Parish Councils' Response to Local Plan Technical Assessment
(Site Ref HatfieldBO 005 MIX)

SLAA Technical Consultation

Site Ref HatfieldBO 005 MIX

HatfieldBO 005 MIX

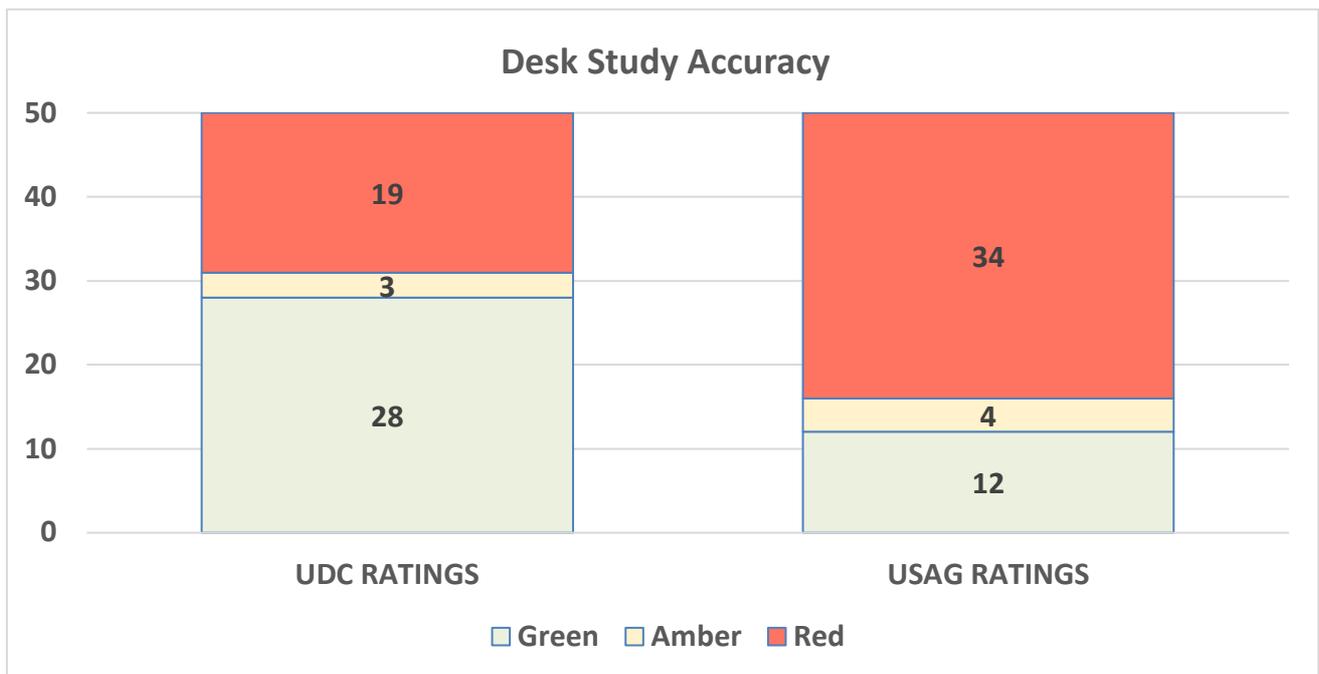
USAG has identified significant flaws in the methodology and a number of misleading and inaccurate entries on the form for site HatfieldBO 005 MIX.

USAG has identified these inaccuracies in this detailed submission.

**Based on our findings, USAG considers the technical assessment produced
by UDC has important limitations
and cannot provide a realistic assessment of site suitability.**

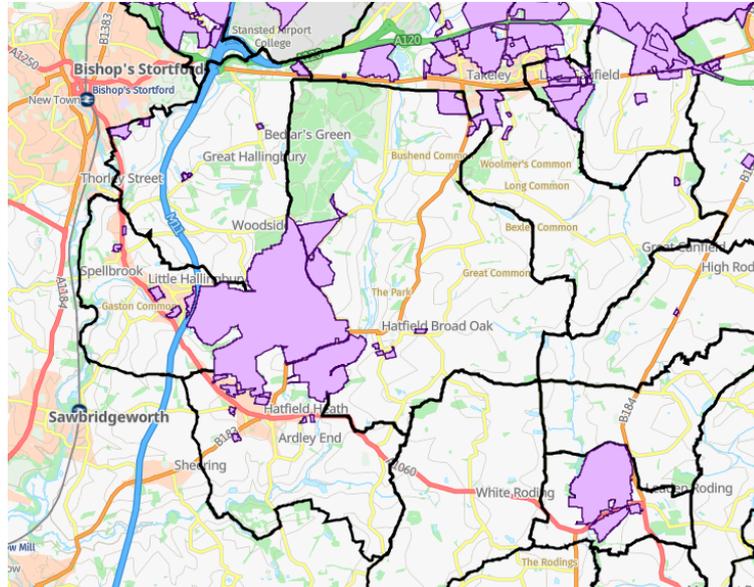
23	Poor Air Quality Zone
	<p>The UDC report highlights the site as being in a Poor Air Quality Zone.</p> <p>THIS BOX IS RED</p>
24	Noise Contours
	<p>Firstly, it must be said that the RAG rules relate to out-dated noise contour levels. The 57dba contour has been superseded by a lower level of 54 dB LAeq for SOAEL (Significant Observed Adverse Effect Level). In 2014, the DofT commissioned a research paper Survey of Noise Attitudes ('SoNA'), designed to investigate attitudes towards aviation noise and how these have changed over time. This was published in February 2017 and builds on the levels outlined in the Department for Environment, Food and Rural Affairs ('Defra') Noise Policy Statement for England ('NPSE') It says: "significant community annoyance previously observed around 57 dB LAeq is now observed from 54 dB LAeq. This finding is supported by another study by Defra which suggests a LOAEL for aviation likely lies in the range of 50-54 dB LAeq, well below the current 57 dB measure of the onset of significant community annoyance</p> <p>The DfT Impact Assessment ('IA') for Assessing Aviation Noise Impacts states that the intention is to set 51dB LAeq for daytime and 45dB LAeq for night time as the LOAEL (Lowest Observed Adverse Effect Level) threshold.</p> <p>For night noise, the World Health Organisation ('WHO') recommends that "considering the scientific evidence on the thresholds of night noise exposure indicated by Lnight as defined in the Environmental Noise Directive (2002/49/EC) ('END'), an Lnight of 40dB should be the target of the night noise guideline ('NNG') to protect the public, including the most vulnerable groups such as children, the chronically ill and the elderly". Indeed, locations of schools and areas of vulnerability should not be located in area of the Hatfield Garden Community Site. Reference can also be made to the standard for building regulations for schools known as BB93 Acoustic Design of Schools – performance standards. https://www.gov.uk/government/publications/bb93-acoustic-design-of-schools-performance-standards</p> <p>The Government's Aviation Policy Framework ('APF') dated March 2013 states: <i>"The Government recognises that noise is the primary concern of local communities near airports and we take its impact seriously. As a general principle, the Government therefore expects that future growth in aviation should ensure that benefits are shared between the aviation industry and local communities. This means that the industry must continue to reduce and mitigate noise as airport capacity grows".</i></p> <p>Since the March 2013 APF, government policy on aviation noise has been undergoing emerging changes both for Airspace Policy and Aviation Strategy leading to a revised Aviation Policy Framework. Changes are, inter alia, designed to increase community protection against aviation noise harms. Included are 'lower threshold levels for the onset of community annoyance together with health and quality of life impacts. The Government admitted "...recent evidence suggests people are becoming more sensitive to noise at lower levels and that the number of flights overhead can be a more significant factor than the average noise level. Consequently, the average noise metric is increasingly out-dated as the true measure of aircraft noise disturbance. It is being supplemented by 'number above' metrics which provide contours for total numbers of aircraft noise events that exceed a range of maximum noise levels. This is a much better assessment of what people actually hear. All of European departures on Stansted's Runway 22 would produce noise events for the garden community site.</p>

With the airport growing and having recently obtained permission to extend to 43mpa it is incumbent not only on the airport to reduce its noise output. The WHO states that “To reduce health effects, the GDG strongly recommends that policy-makers implement suitable measures to reduce noise exposure from aircraft in the population exposed to levels above the guideline values for average and night noise exposure. For specific interventions the GDG recommends implementing suitable changes in infrastructure. Those changes in infrastructure impose a duty on LPA’s to ensure no new communities are built in areas of unsustainable noise.

The 2019 54 dB daytime noise contour

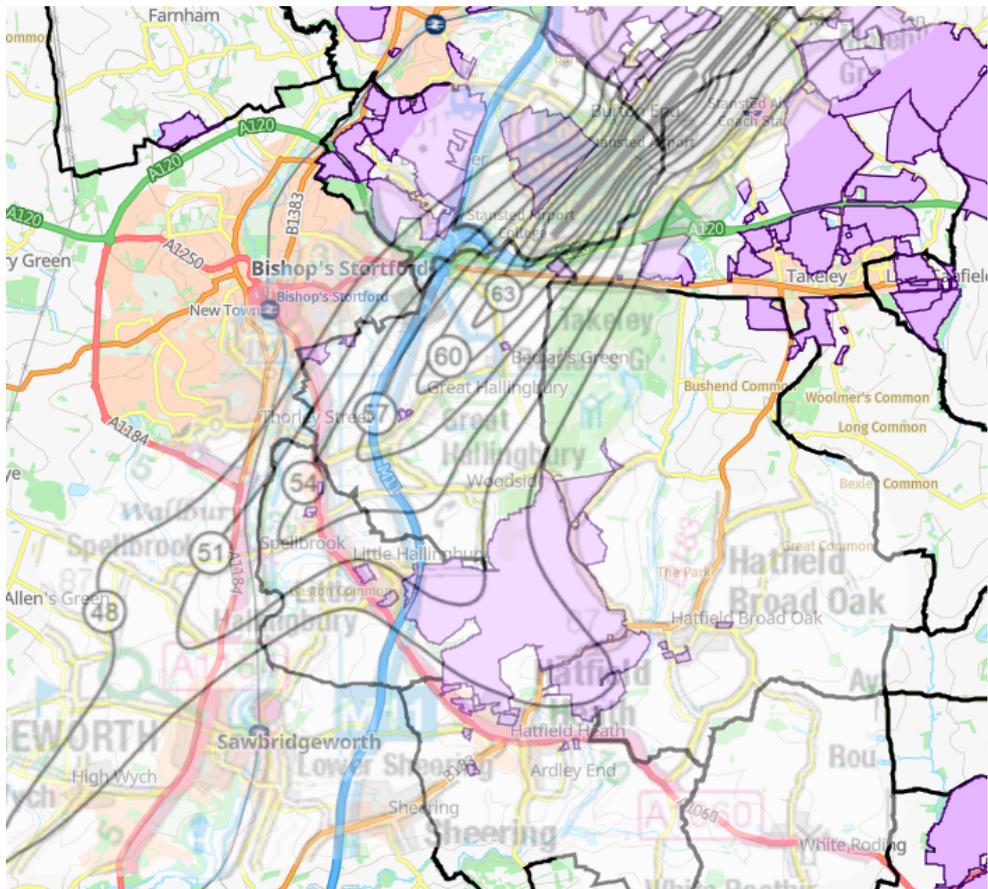
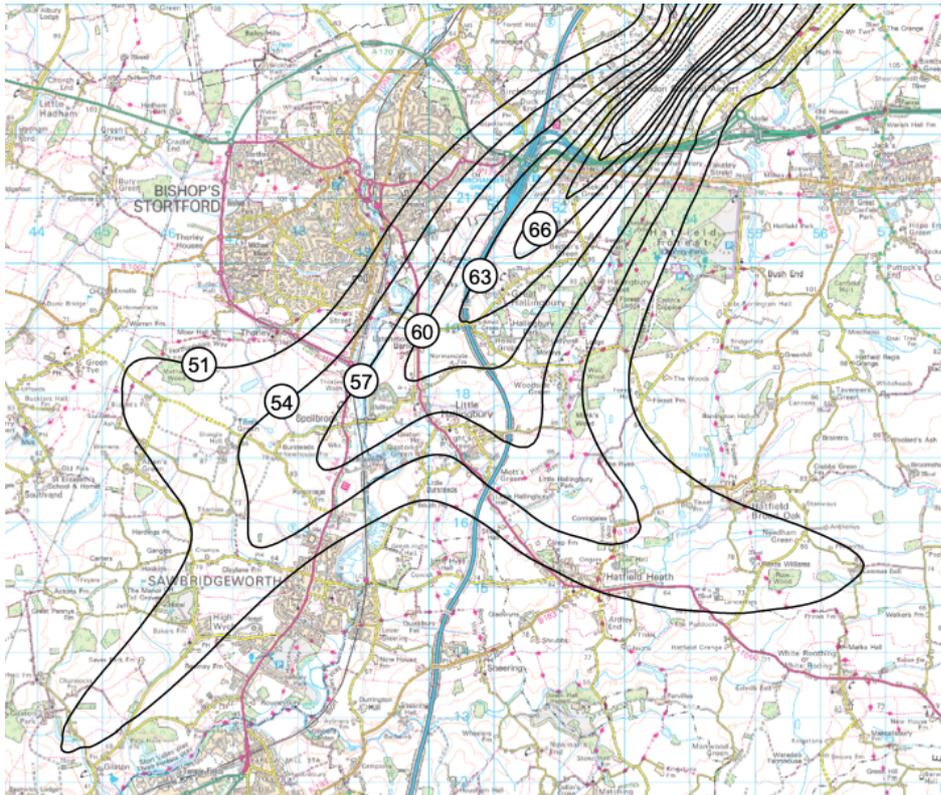
The 2019 night noise contours showing the entire site well within the 48 dB contour and considerably above the WHO guidelines

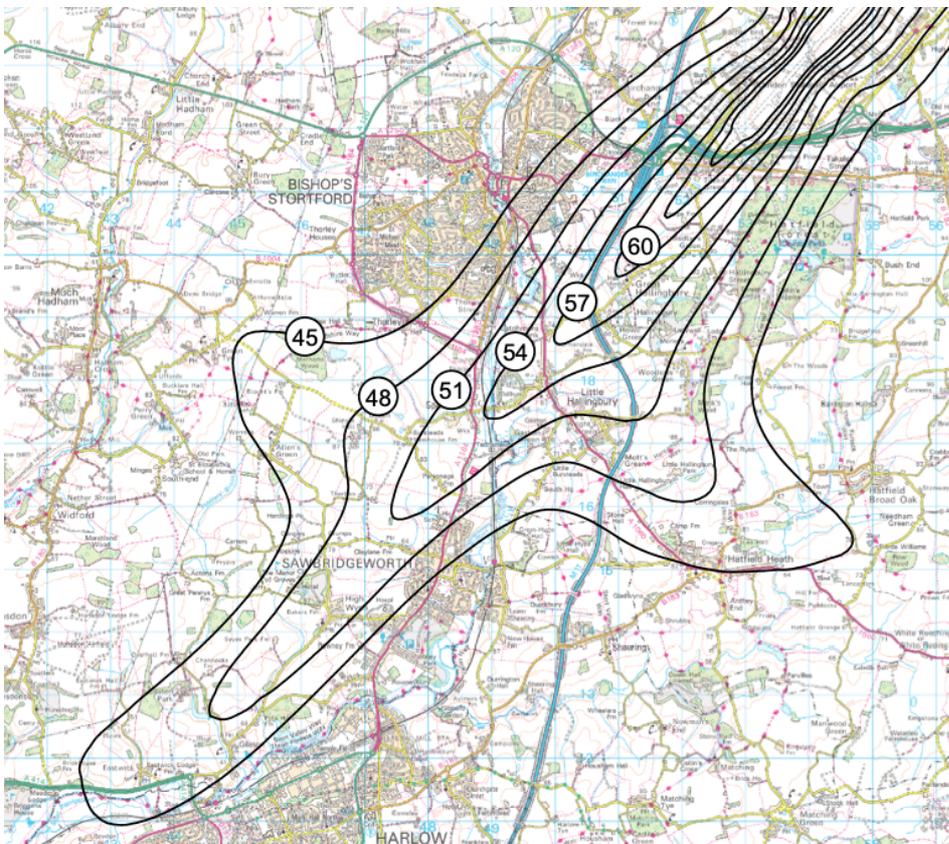
With expansion of Stansted now granted, the inquiry was evidenced with projected noise contours for 2032. Clearly all of the garden community site falls within the 51-57dB contour

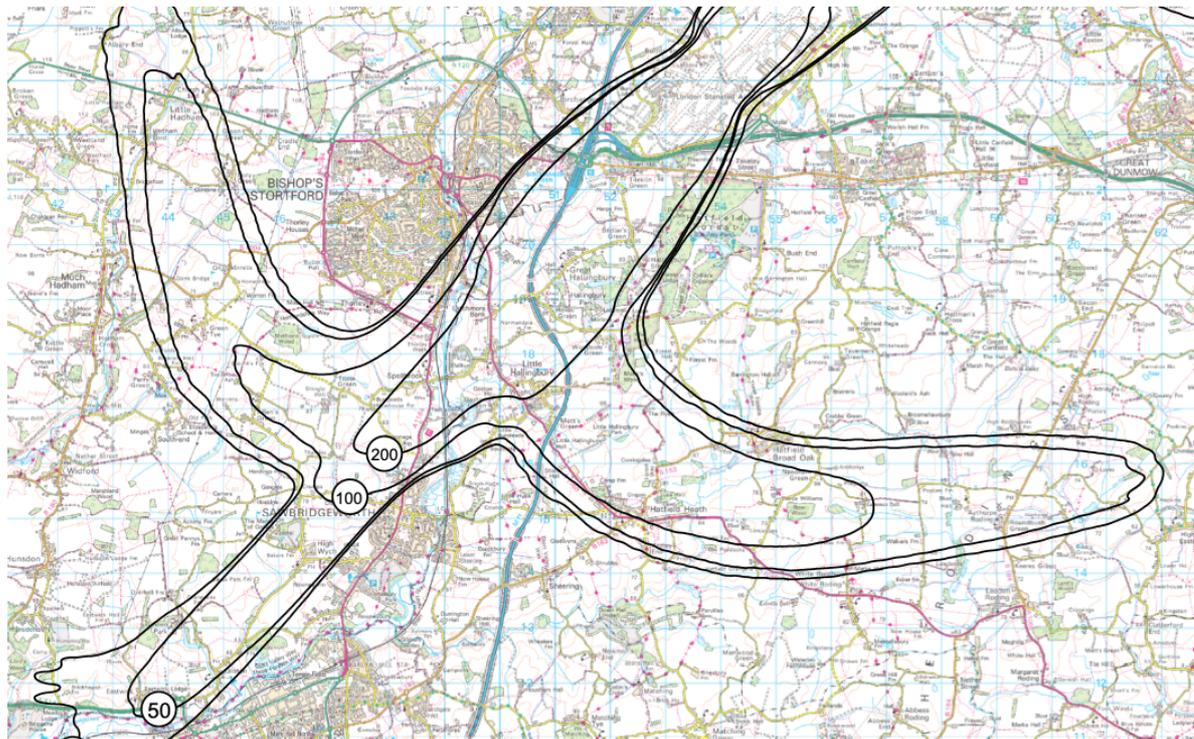
The entire site falls within the 45-51 LAeq contour in excess of the night-time limits recommended by WHO.

When using the more respected 'N' contours (numbers above), denoting the number of events above a defined noise threshold, it can be seen there would be between 100 and 200 noise events per day of 65db over the garden community site.

Much of the site would be at a higher noise event level and these contours should be established. These are actual events rather than 16 hour averages. This alone makes the garden community site not only unsustainable but unbearable place to live with considerable health and wellbeing impacts.

THIS BOX SHOULD BE RED NOT GREEN
